# **Transportation Impact Assessment**

## **PROPOSED GAS STATION DEVELOPMENT**

8605 Campeau Drive, City of Ottawa

**Re: Transportation Impact Assessment - Addendum  
Proposed Gas Station Development  
8605 Campeau Drive, City of Ottawa  
Our Project No. NT-20-091**

**PROPOSED SITE LAYOUT WITH CAR WASH**

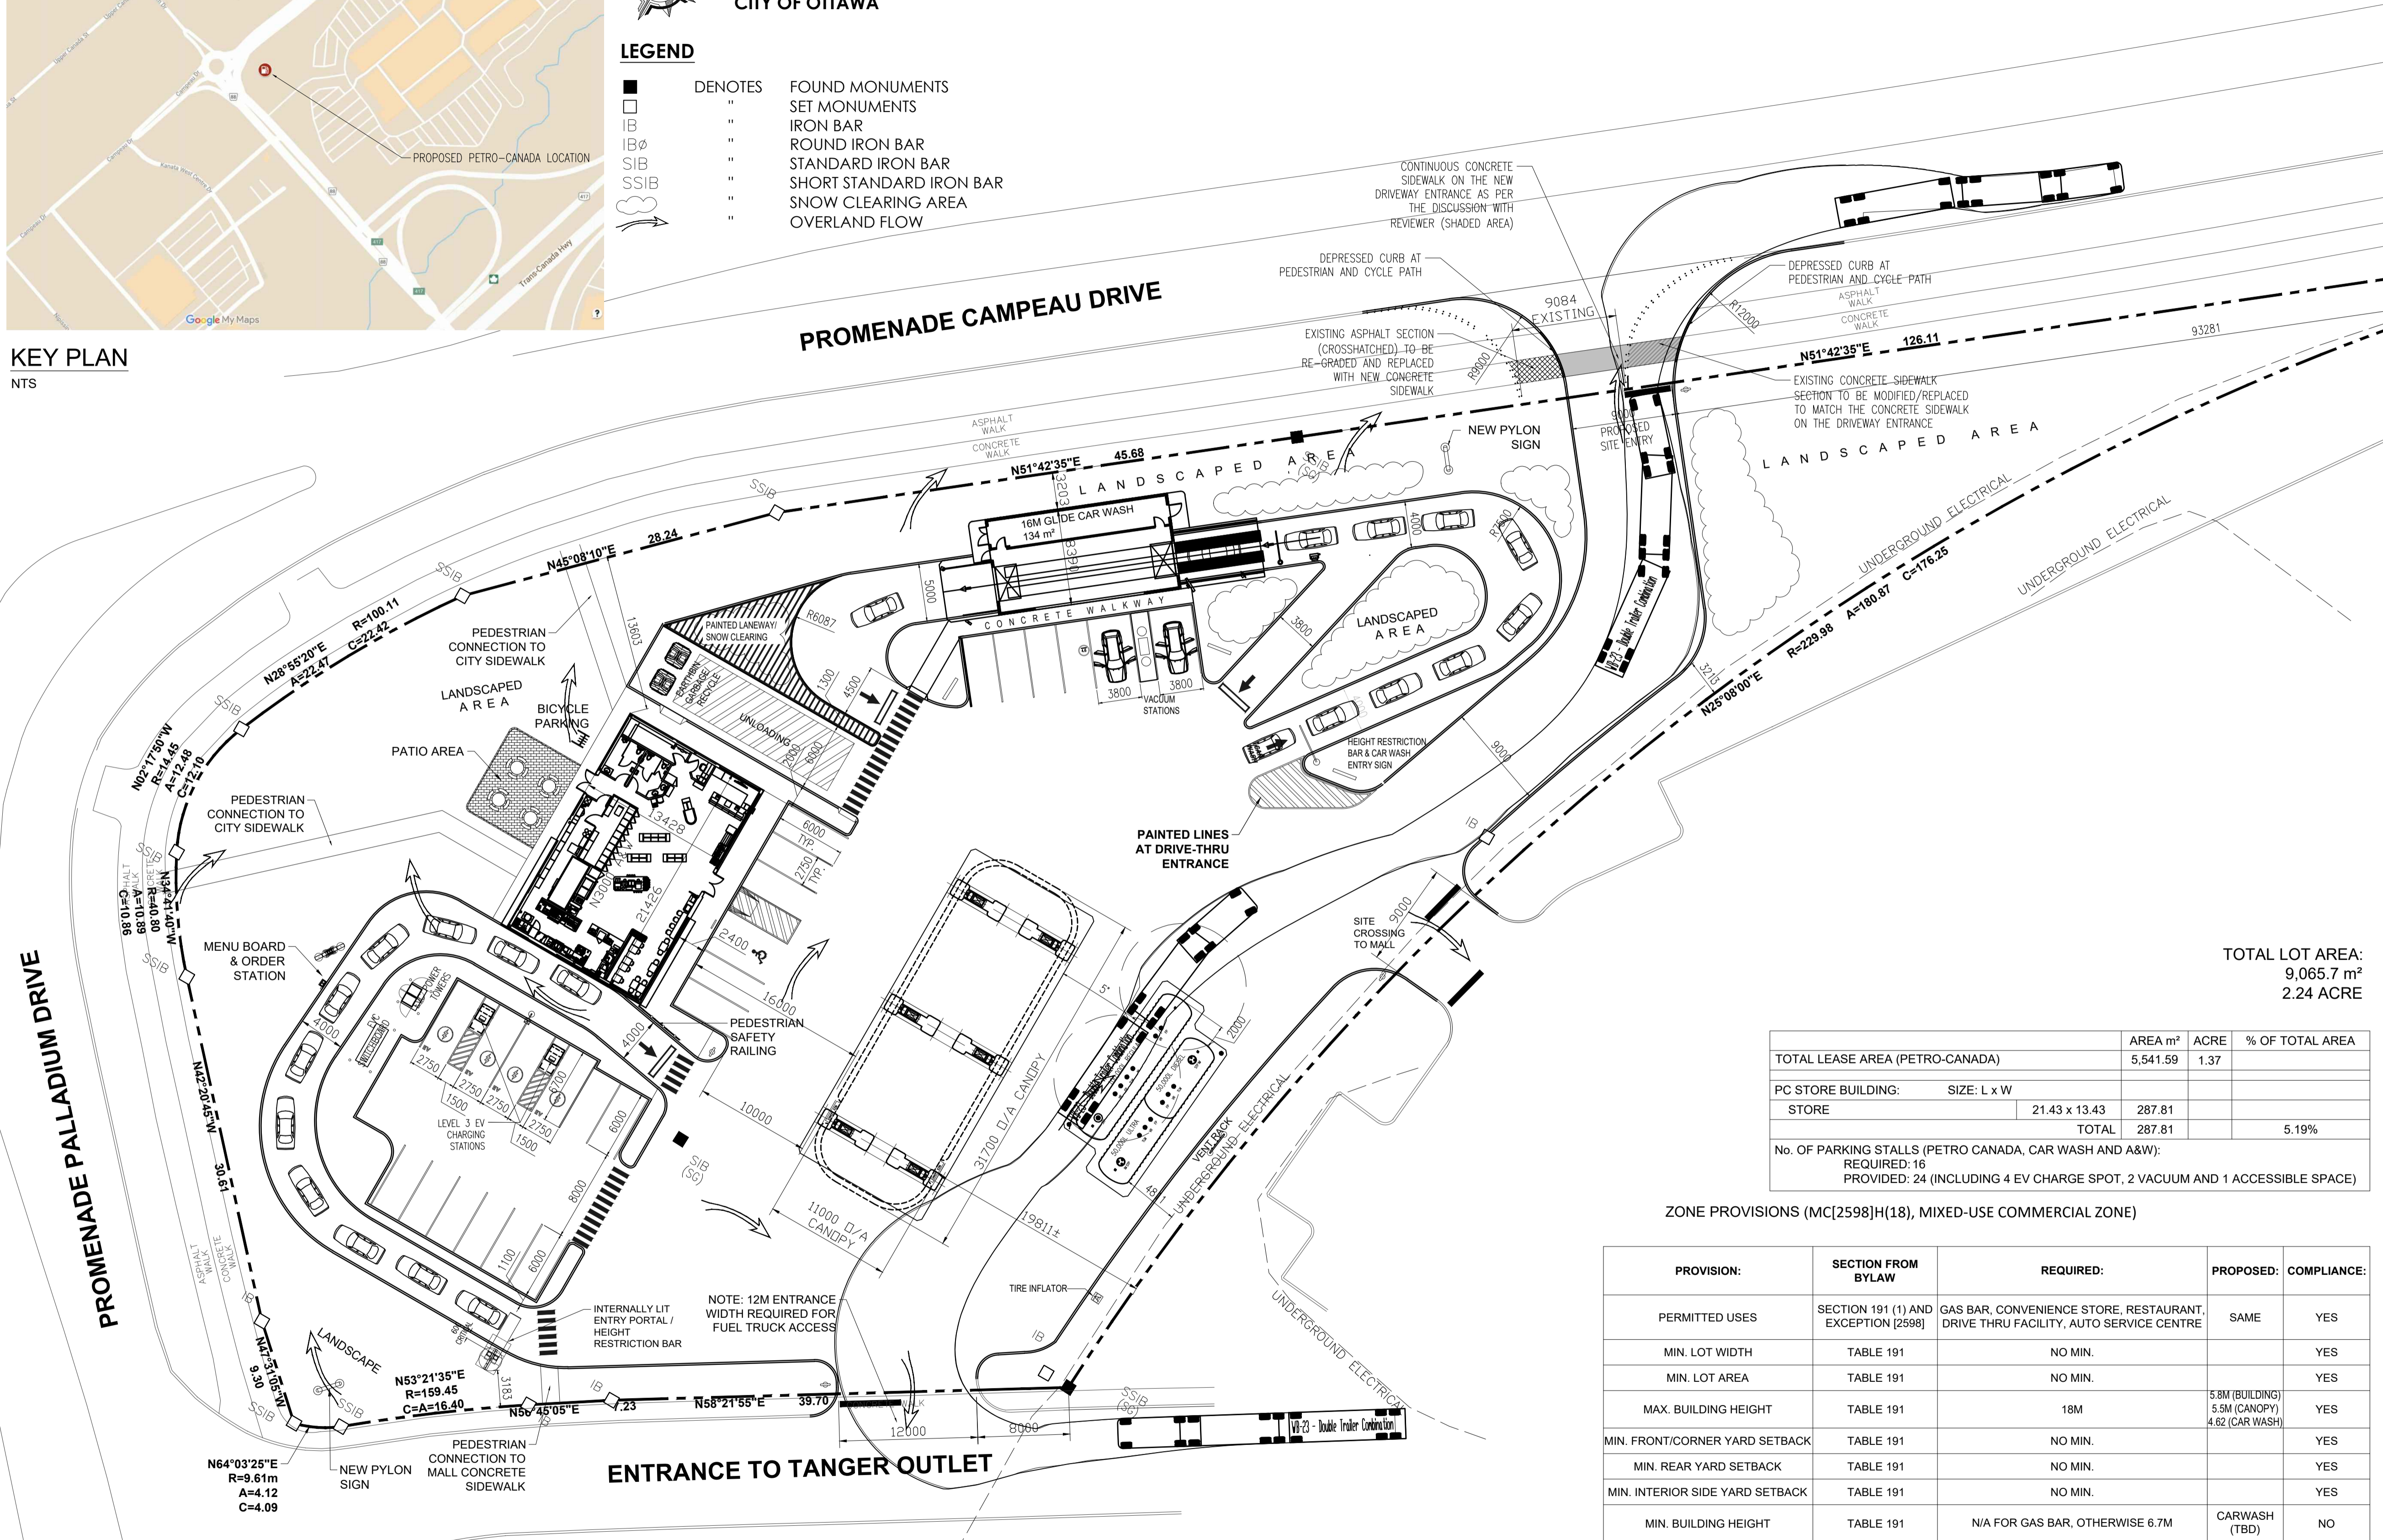
- 2.1. *The Campeau access must have the cycle track and sidewalk be continuous and depressed (TWSIs).*

**Response:** Acknowledged. Site plan will be revised.

REVISION	
1	2023-02-08 ADDED LEVEL 3 EV CHARGERS, SHOWING LG ELECTRICAL LINES, SHIFTING LG TANKS, SHOWING DEPRESSED CURBS AT CYCLE/PEDESTRIAN CROSSING
